## ADDENDUM

**PROJECT:** State of Nebraska  
Grand Island Veteran's Home  
WWII / Phillips Building  
Mechanical, Electrical, and ADA Upgrades  
Grand Island, Nebraska

AD-3

**DATE ISSUED:** Thursday, January 26, 2012

**SHEET NUMBER**  
 M-206

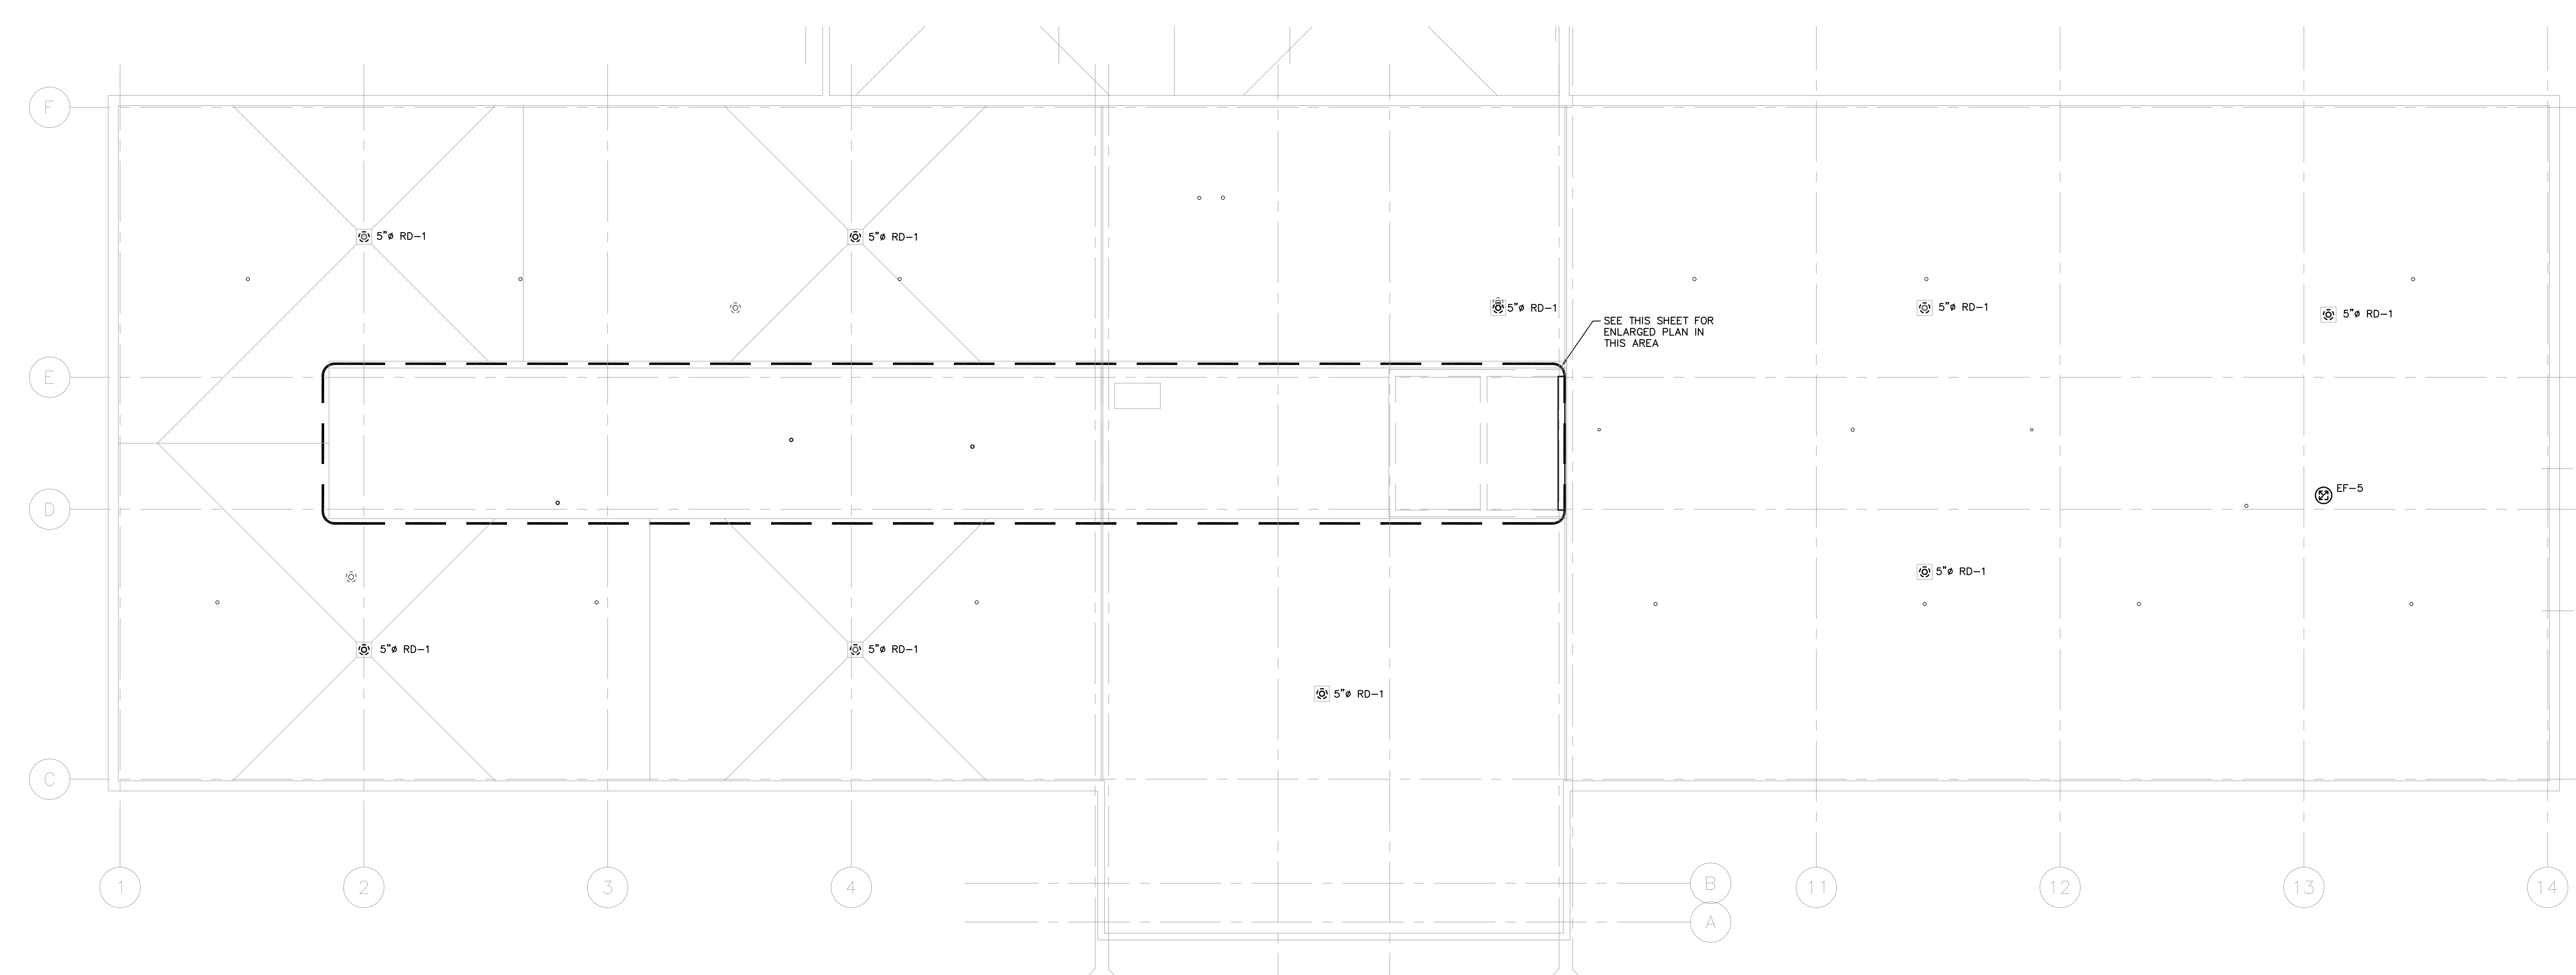
**In reference to drawing M-206**, refer to revised drawing M-206 for changes to piping.

**REVISED  
 ROOF DRAINS  
 & ROOF  
 DRAIN PIPING**

SHEET NUMBER  
**M-207**

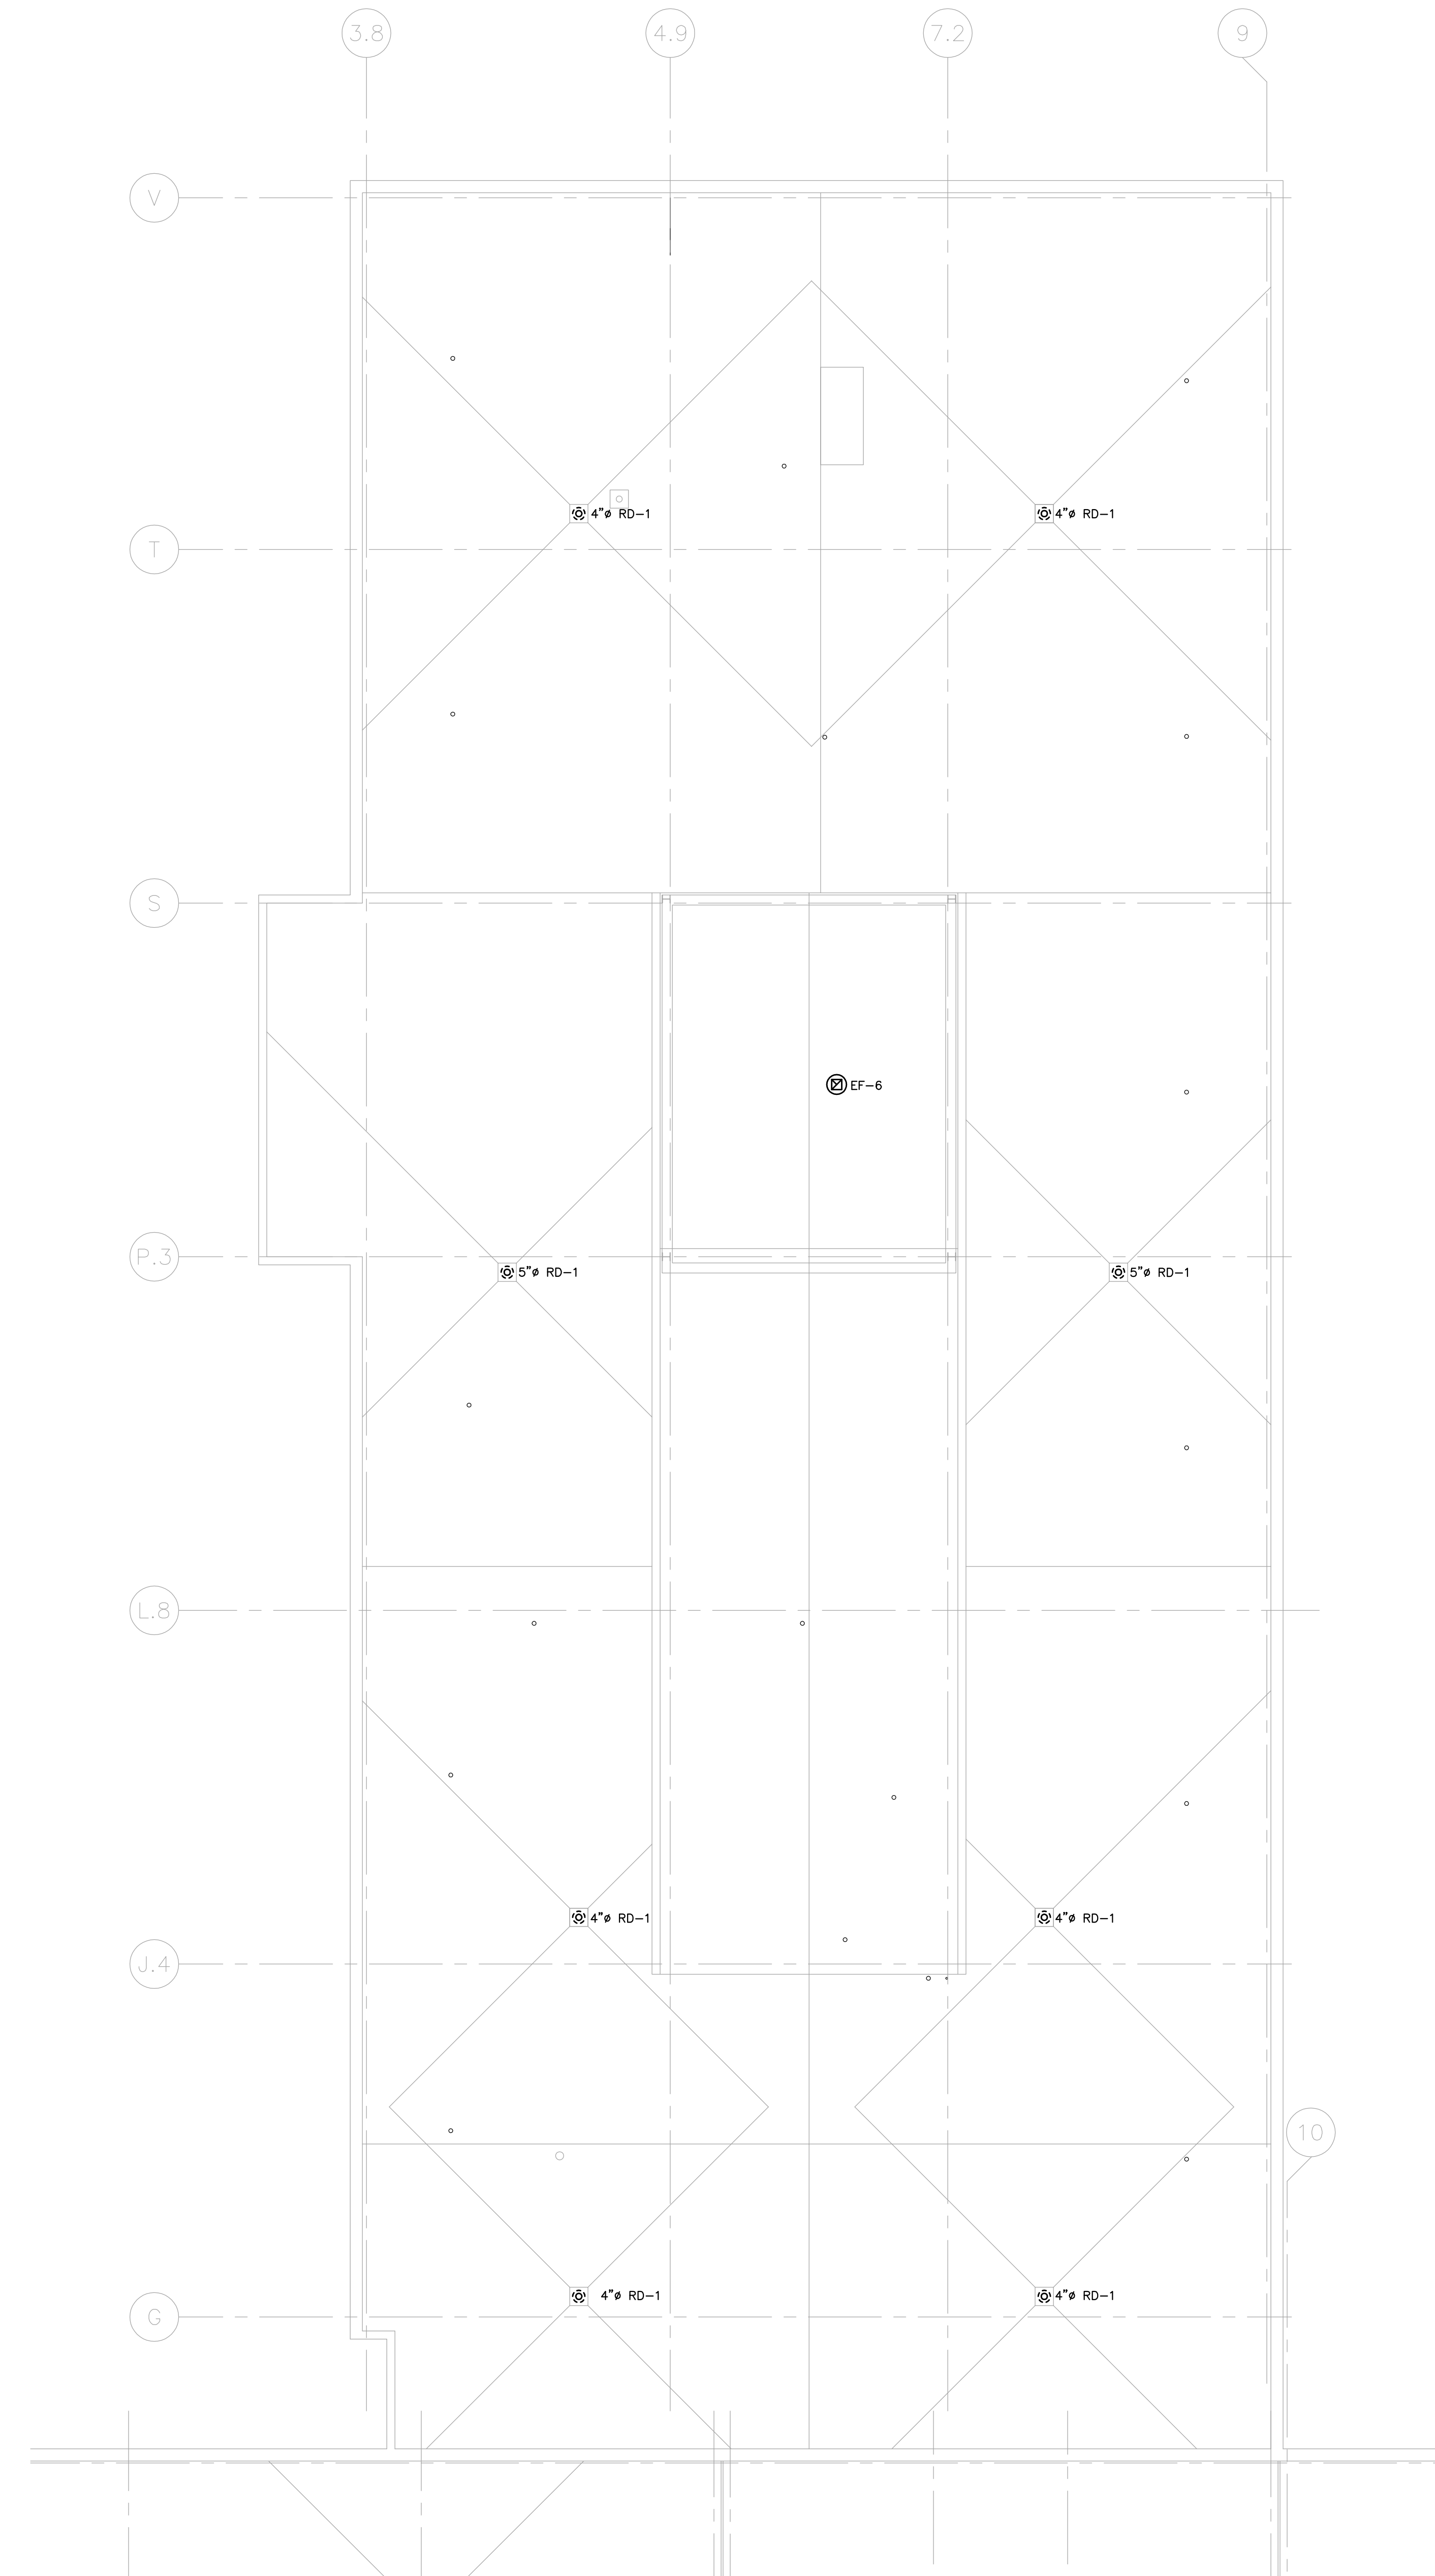
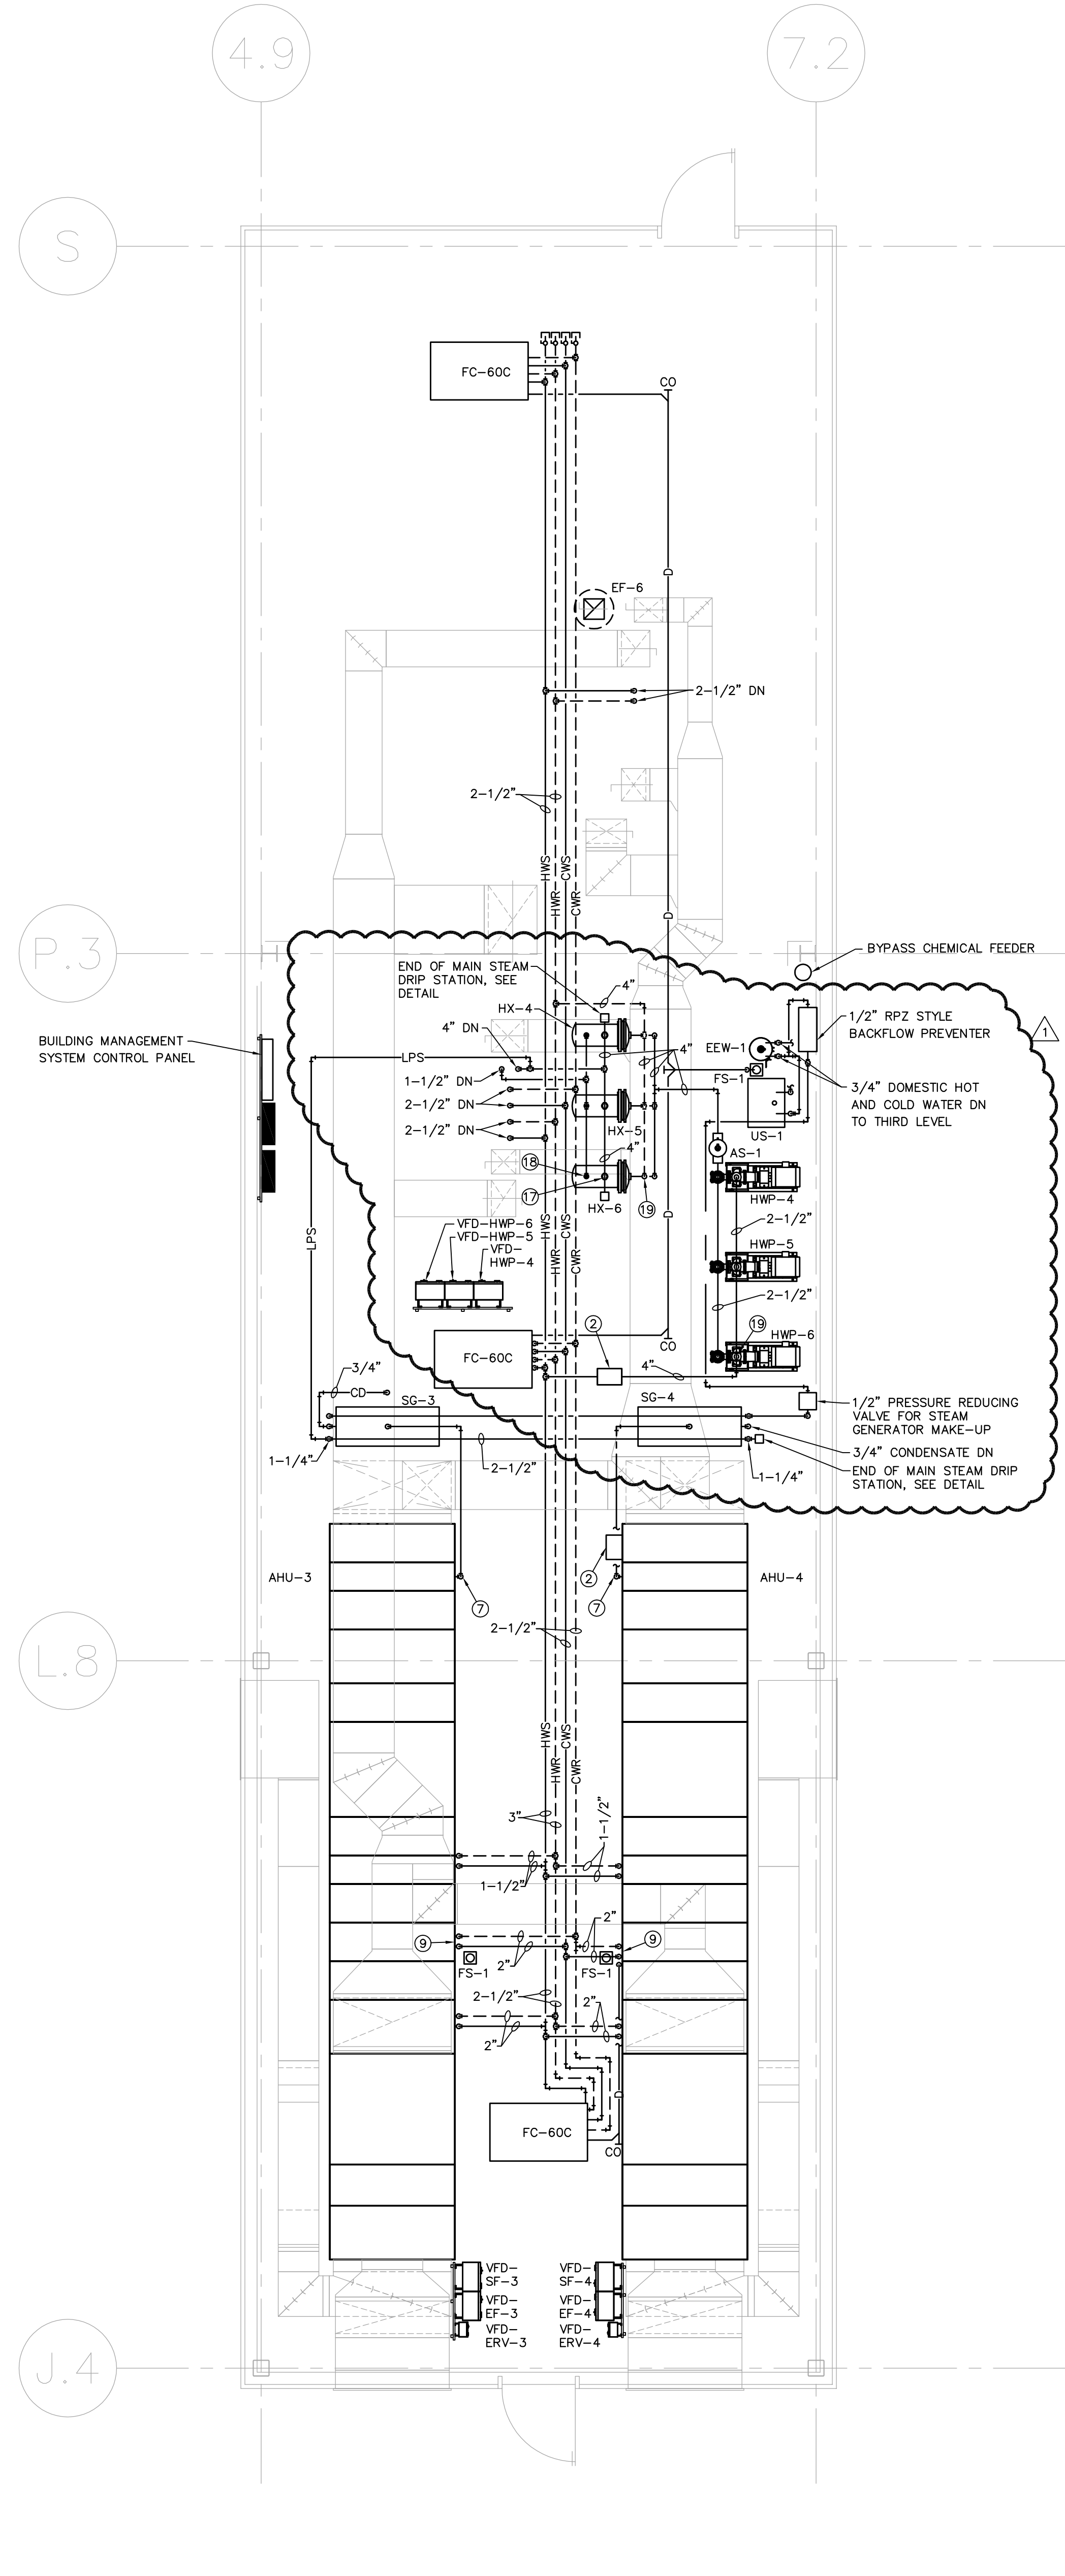
**In reference to drawing M-207**, refer to revised drawing M-207 for changes to piping.

**REVISED  
ROOF DRAINS  
& ROOF  
DRAIN PIPING**
